MARQUETTE CITY PLANNING COMMISSION
Tuesday, March 24, 2026, at 6:00 p.m.
Commission Chambers at City Hall – 300 W. Baraga Ave.

TO: Planning Commission
FROM: Andrea Landers, Zoning Official
DATE: March 11, 2026
SUBJECT: **01-CSD-03-26 & 02-SPR-03-26 – McClellan Meadows Site
Condominiums (PIN: 0512412)**

TO: Barry Polzin Architects
FROM: Andrea Landers, Zoning Official
DATE: February 27, 2026
SUBJECT: 01-CSD-03-26 - Review of the plan submitted dated 2-17-26 for – No address McClellan Ave (PIN: 52-52-005-124-12)

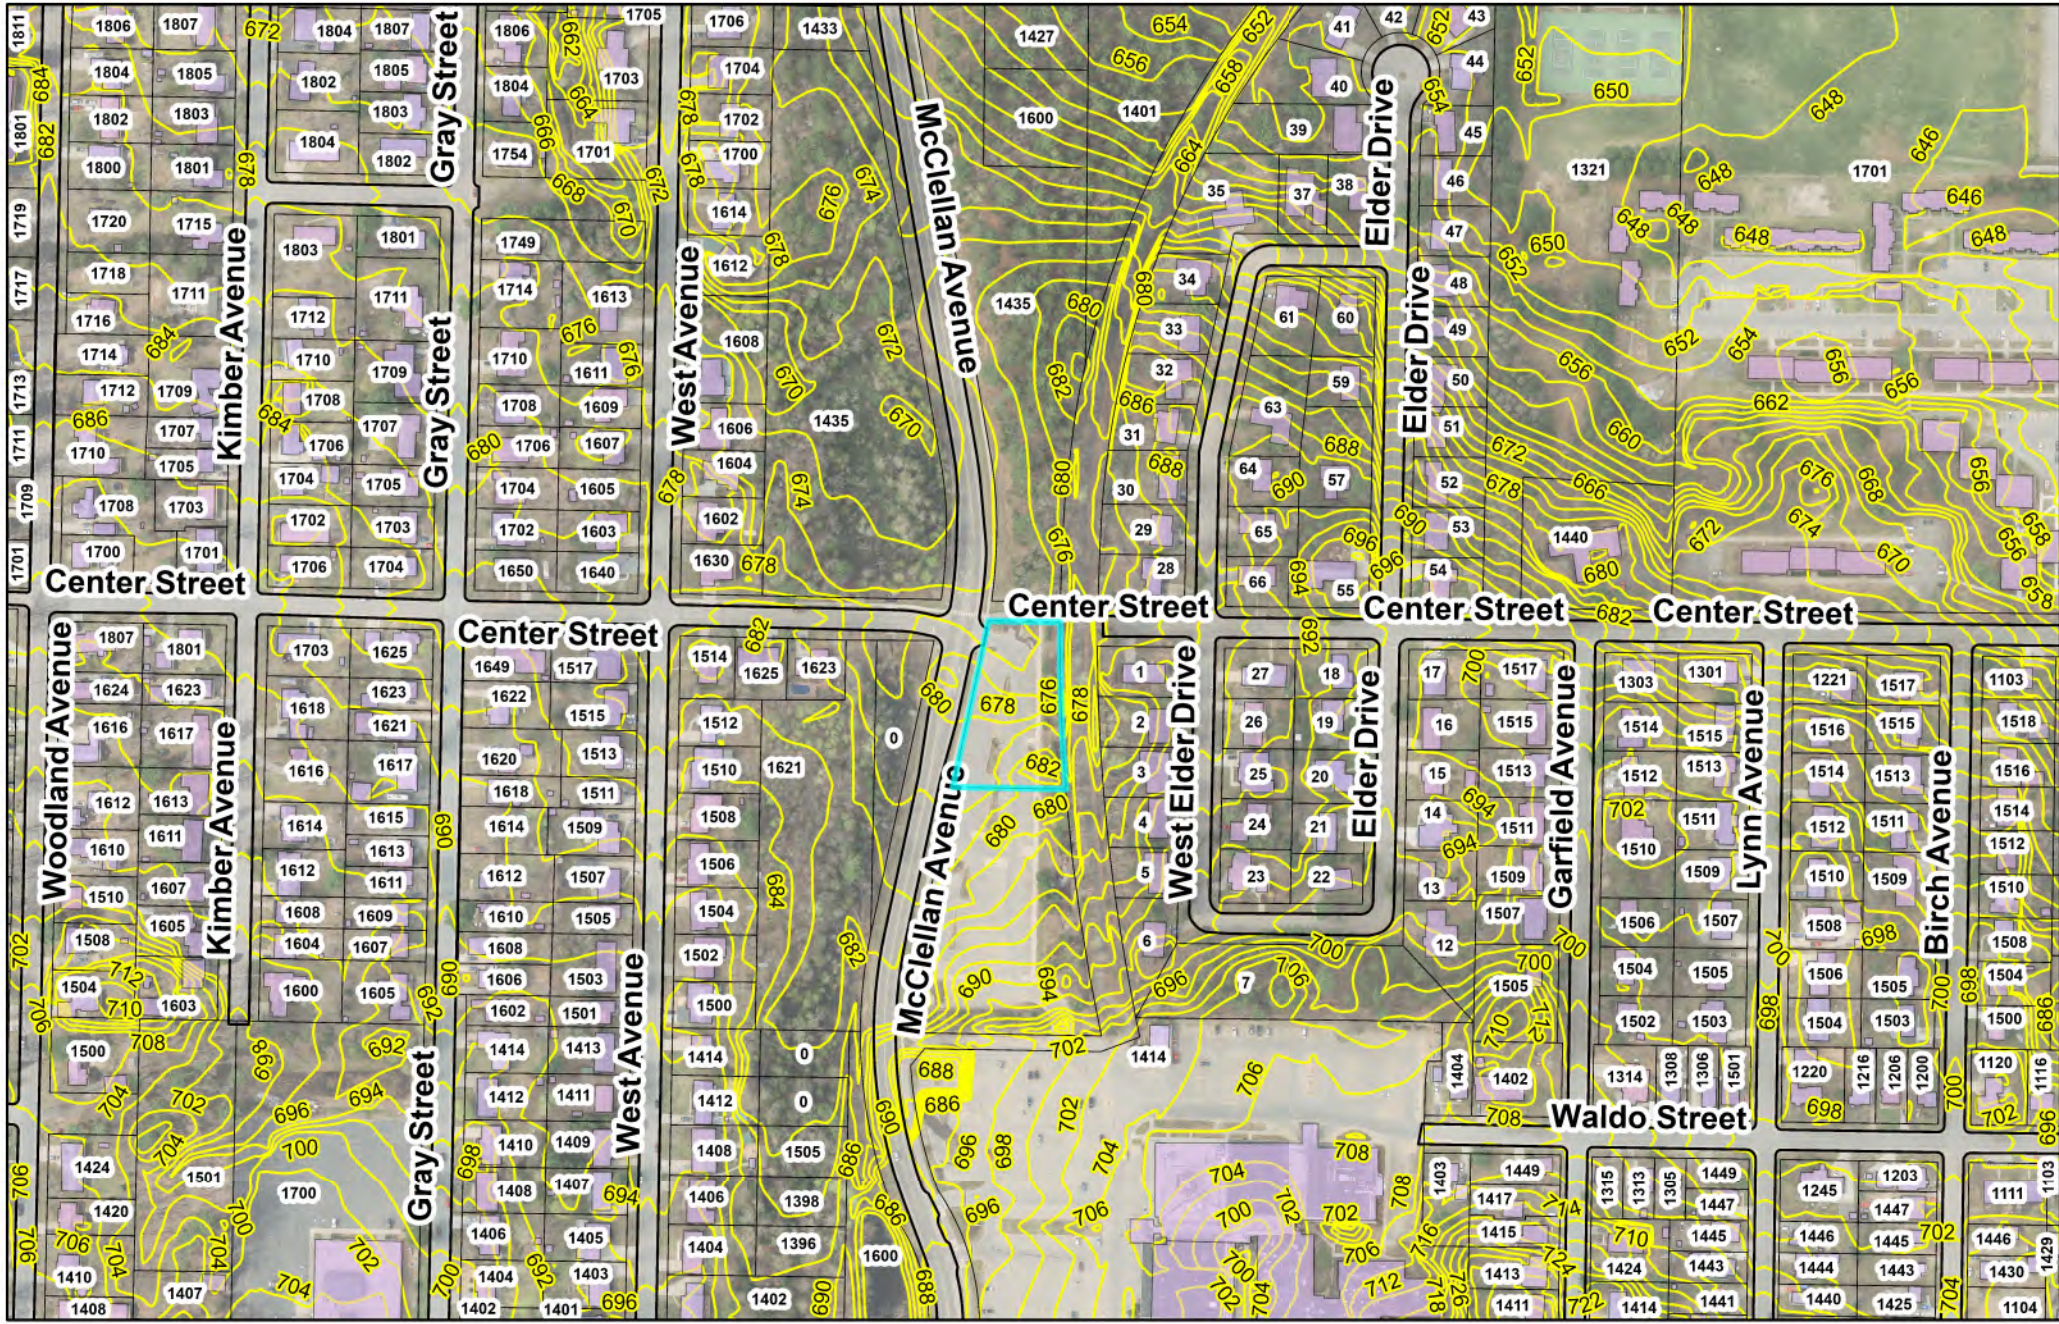
- Please confirm if the hydrant was in fact placed on the property to the south as shown on these drawings. If so, an additional utility easement will be required from that property owner. **We will confirm if placed on neighboring property that easement has been provided to the city.**
- Please see attached drawing for additional comments. **Additional comments received.**

Figure 6. Yard Terms

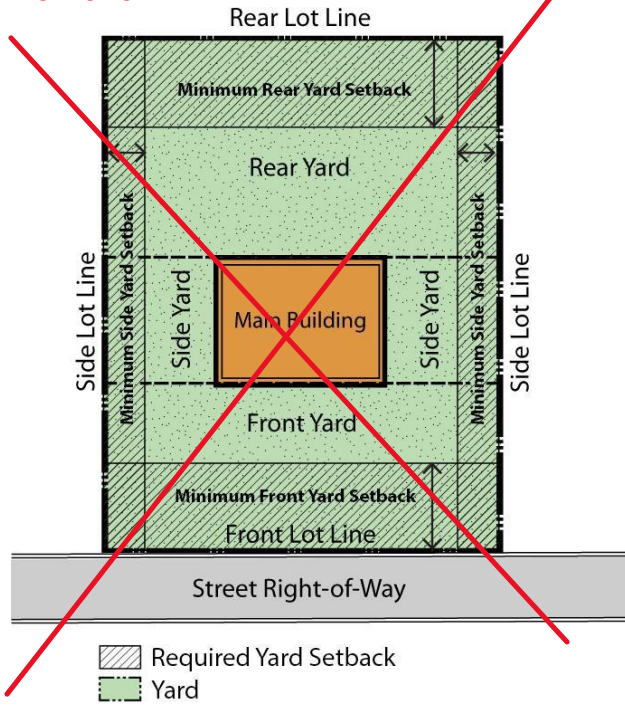
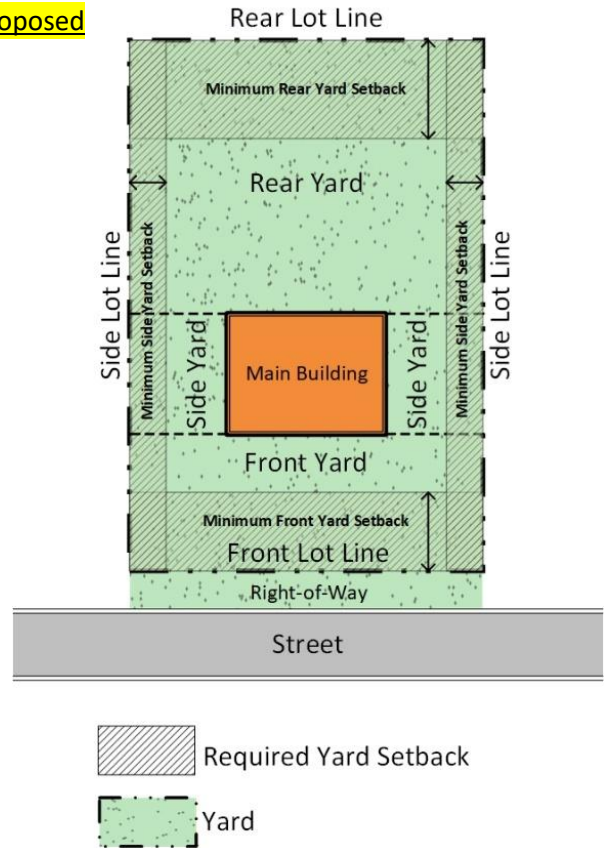
Add a Through Lot drawing as a new Figure 8. Update the existing drawings for Figures 6 & 7.
